**** BLM REVISED ** BLM REVISED ** BLM REVISED ** BLM REVISED ** BLM REVISED ****

PLUG AND ABANDONMENT PROCEDURE

Jicarilla Apache Tribal 151 #2

Re: Permanent Abandonment
Well: 2 Jicarilla Apache Tribal 151

Proposed P&A

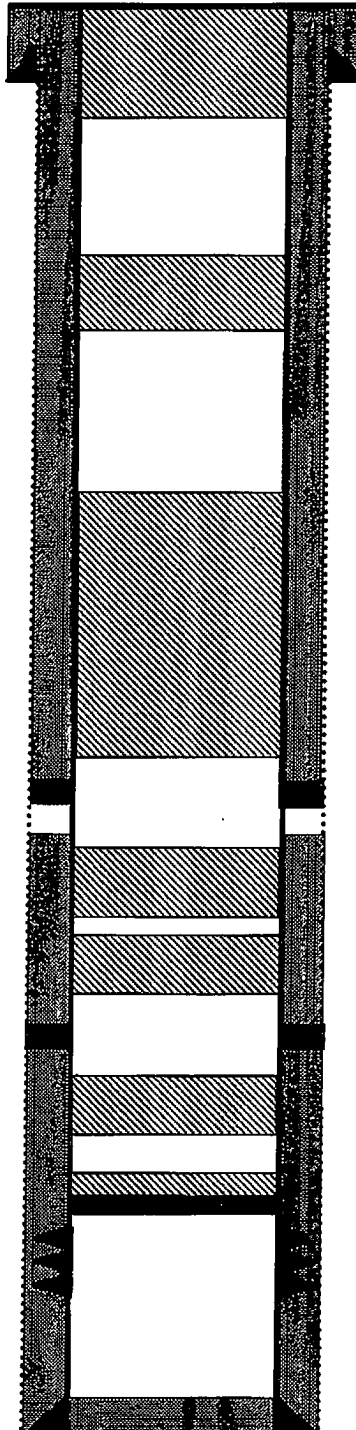
1932

Ojo Alamo @ 3440' *est
32 83

Kirtland @ 3438' *est
3500

Pictured Cliffs @ 3836'
3900

Mancos @ 6238'
6386

Gallup @ 7011'
718

1982 1882

3950 3233

TOC @ DV Tool (Calc, 75%) 7128 7028

- a) Place the Gallup plug from 7128' – 7028'.
- b) Place the Pictured Cliffs/Fruitland/Kirtland/Ojo Alamo plug from 3950' – 3233'.
- c) Place the Nacimiento plug from 1982' – 1882'.
